Office Action Summary

10/540,011

BALTES ET AL.

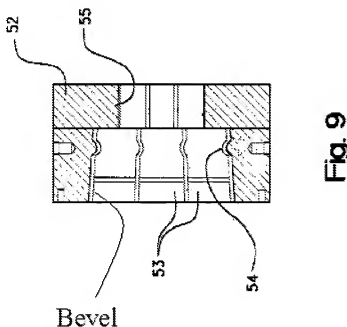
In regards to Claim 1, Bizak discloses a piston type accumulator having an accumulator housing, ("cylindrical casing", Col. 4, lines 51-52, Fig. 1), and a freely slidable separating piston 48 (Fig. 1) which is displaceable in the longitudinal direction and which separates two working chambers. (Col. 1, line 53-55) Bizak further discloses the accumulator housing being sealed on each of the end sides by a cover component 15, 28 (Fig. 1) which are fastened to the accumulator housing by way of the free longitudinal edge 10 (Fig. 1) of the accumulator housing (See Col. 2, lines 31, Col. 2, line 43-45), by way of the threads 34 on the longitudinal edge 10 (Fig. 1), which for this purpose undergoes a positioning movement onto the cover component 15, 28.

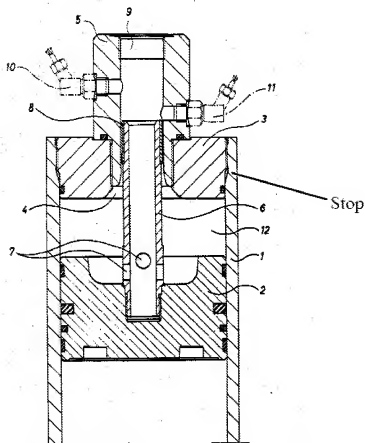
In regards to Claim 2, Rajabi discloses all of the recited structure with the exception of one side of a cover component inserted into the accumulator housing so as to come to rest against a stop. However, Audureau teaches a cover component 2 (Fig. 1) inserted into the accumulator housing and coming to rest against a stop 25 (Fig. 1). The cover component 2 is retained in its end position by the clamping force of the positioned free

longitudinal edge 24 (Fig. 1). Therefore, it would have been obvious to one with ordinary skill in the art at the time the invention was made to combine the use of a stop as taught by Audureau with the invention disclosed by Rajabi for the purpose of ensuring that the cover component is placed into the desired location in relation to the accumulator housing.

In regards to Claim 6, Rajabi discloses all of the recited structure with the exception of the opposite side of a cover component having a contact surface in the form of a securing bevel against which the longitudinal edge rests in the secured state. Audureau teaches a cover component 2 (Fig. 1) where on the opposite side there is a securing bevel 26 (Fig. 1) against which the longitudinal edge 24 (Fig. 1) rests in the secured state. The cover component 2 closes off the accumulator housing from the exterior. Therefore, it would have been obvious to one with ordinary skill in the art at the time the invention was made to combine the use of a securing bevel as taught by Audureau with the invention disclosed by Rajabi for the purpose of ensuring that the cover component will be held securely in the desired location.

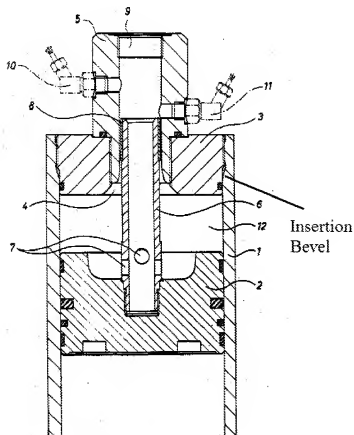
In regards to Claim 5, Rajabi discloses all of the recited structure with the exception of an insertion bevel on the longitudinal edge. Peter teaches an insertion bevel (See picture below; taken from sole Figure) on the longitudinal edge 1 (See sole Figure) which is facing the respective cover component 3 (See sole Figure) and toward the exterior. Therefore, it would have been obvious to one with ordinary skill in the art at the time the invention was made to include an insertion bevel as taught by Peter with the invention disclosed by Rajabi for the purpose of guiding the cover component into the accumulator housing in order to ensure proper installation of the cover component.
